GEOCRES No. 30MB-90

HWY. No. 400/407 IC

LOCATION ADVANCE STRUCTURES

RE: Reinforced Earth Wall Details
Highway 400/407, District 6

N-E, CNR O/H

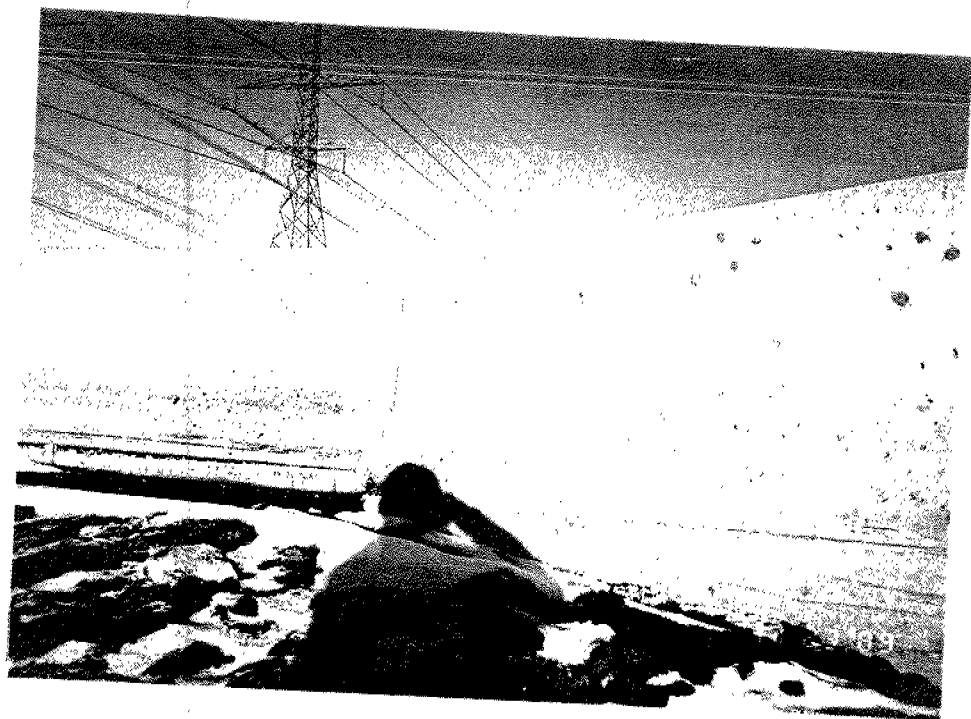
Asphalt patch
to make up
settlement?

Settlement at end
of barrier transition

DETAIL 'A'

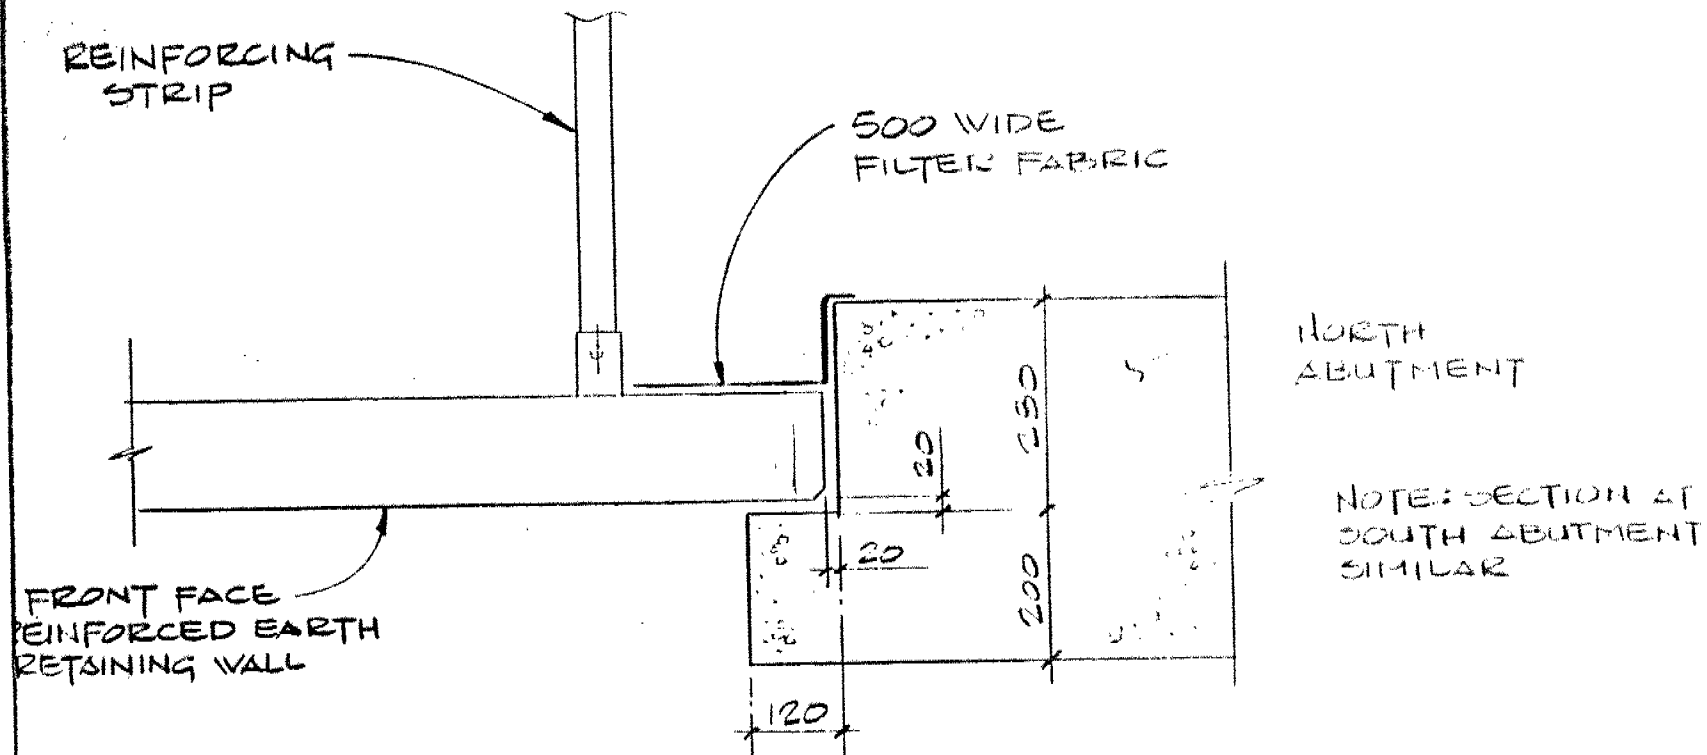
RECO WALL PANELS CONNECTING TO ABUTMENT

Three options were investigated. The option with RECO panels located behind the abutment protrusion of 200mmx120mm is selected. See detail 'A'.

ACTION REQUIRED: This is confirmed in a meeting with G. AlBazi and B. Farago of Structural Office.
Structural Office and Structural Consultants to detail abutment corner to suit.

FOR DETAIL - 'B' INFO.

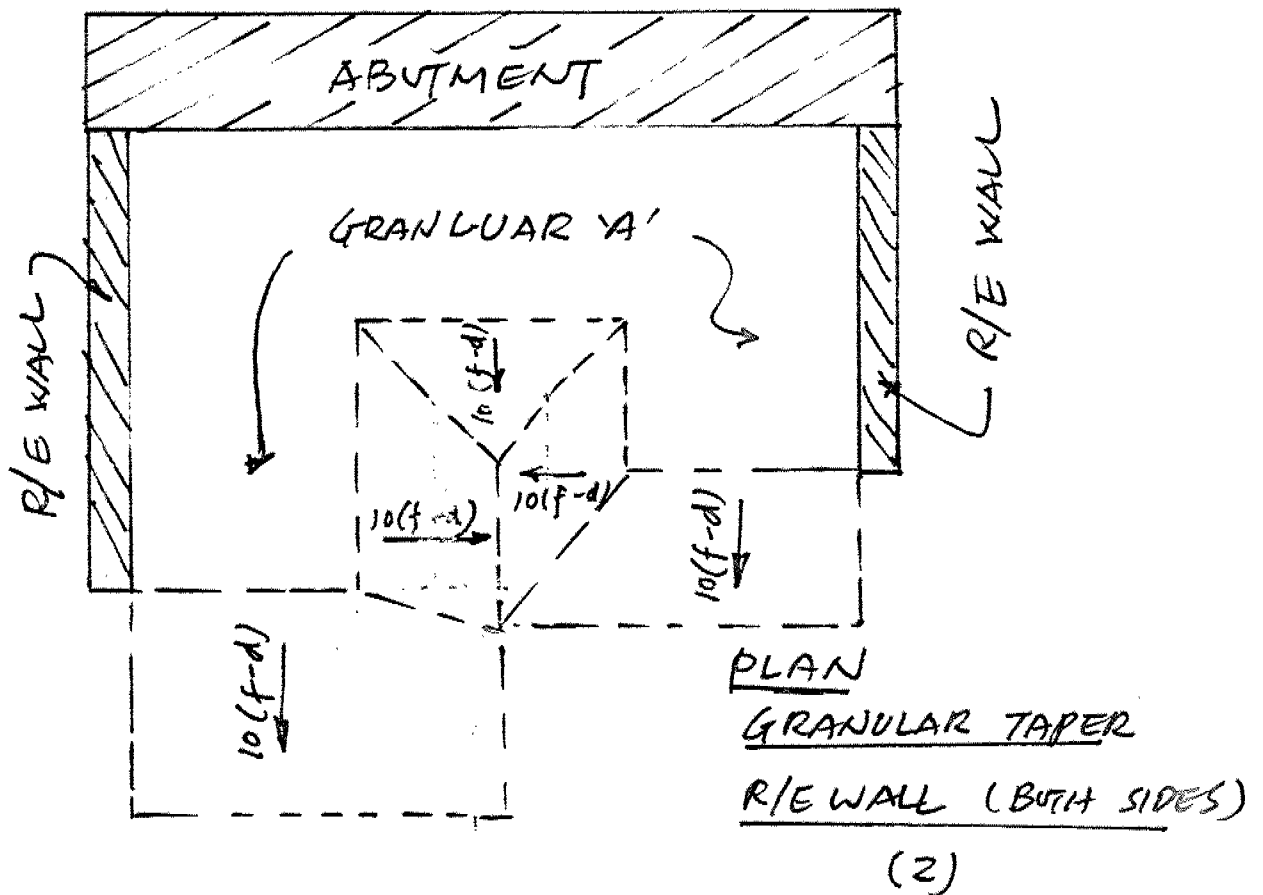
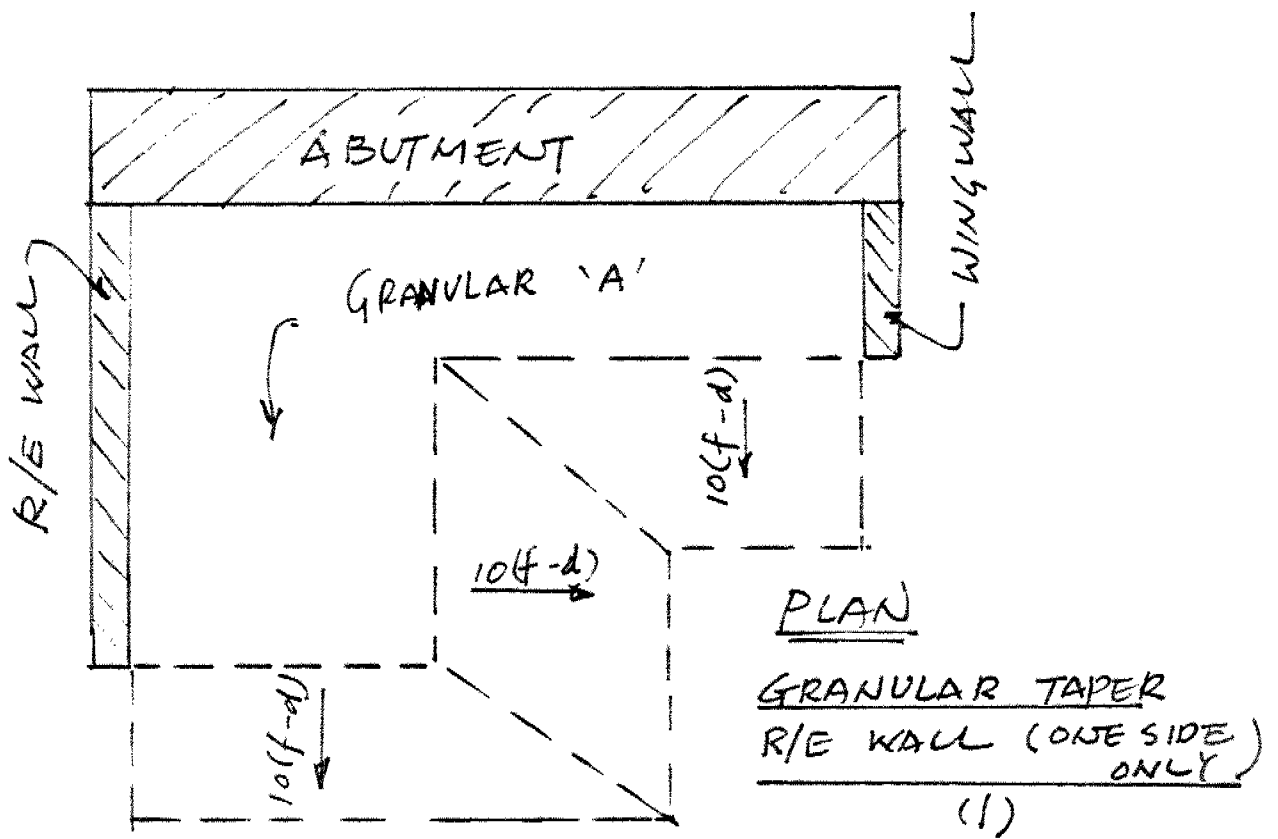
ELECTRICAL DUCT BANKS IN BETWEEN TIE STRIPS OF RECO WALLS

Normally two and maximum three electrical ducts encased in concrete will be installed between tie strips. For three ducts, the standard duct bank size is 250mm high x 550mm wide. These duct banks should be located at a clear distance of 1000mm from the RECO wall panels vertically and in between the strips. See Detail 'B'.

ACTION REQUIRED: RECO has confirmed that the detail is acceptable.

DETAIL 'D'

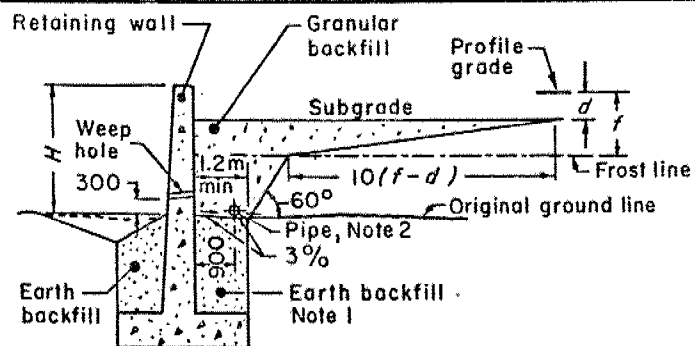
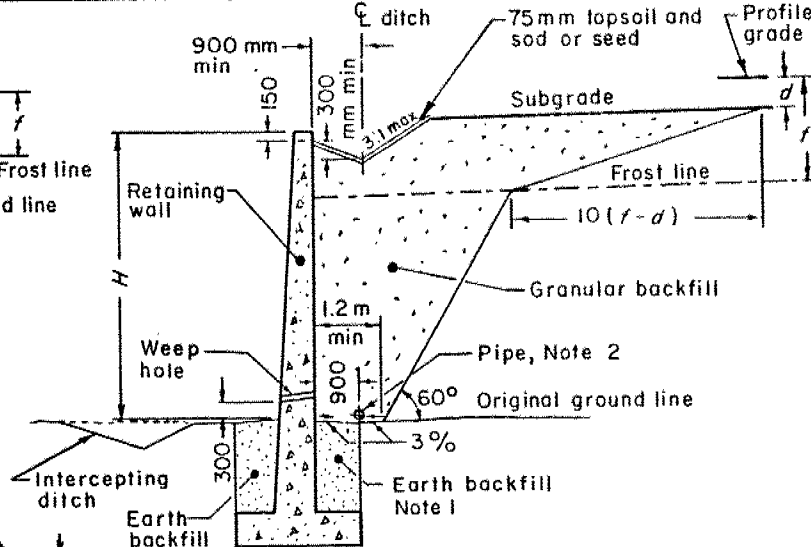
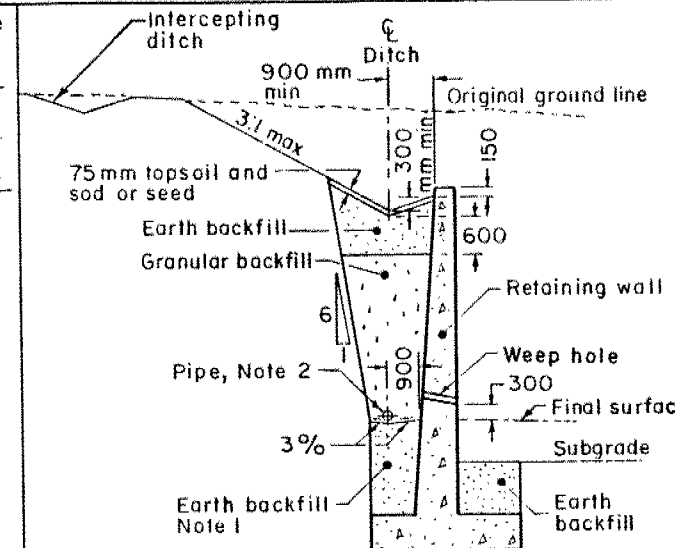
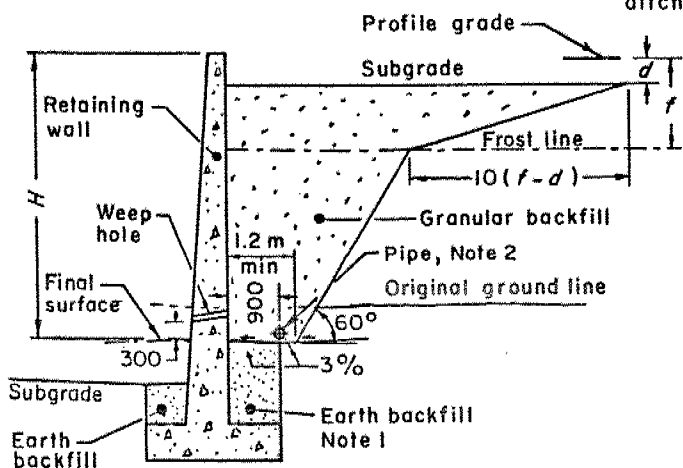
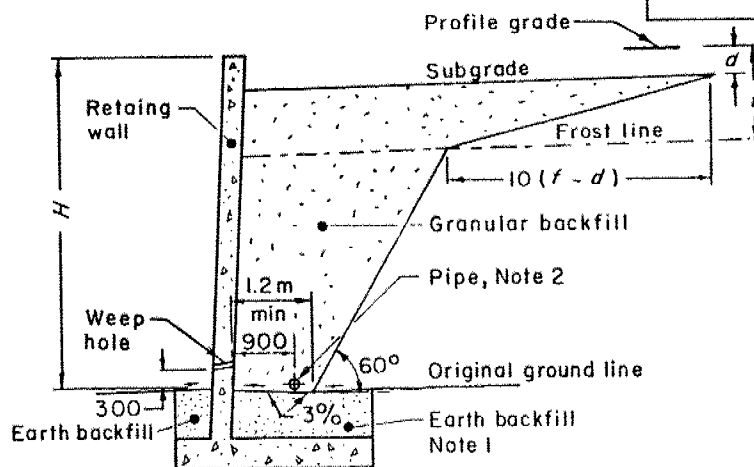
GRANULAR BACKFILL

At the ends of the tie strips, native backfill is used, the differential settlement between granular A and native backfill should be minimized by a layer of tapered granular backfill from the frost line as per DD - 3504. See Detail 'D' & 'E'

ACTION REQUIRED: Structural Section has contacted Foundation Design Section and confirmed the above detail acceptable.
Road Consultants to detail backfill requirements on each structure. RECO and Foundation Design Section to review.
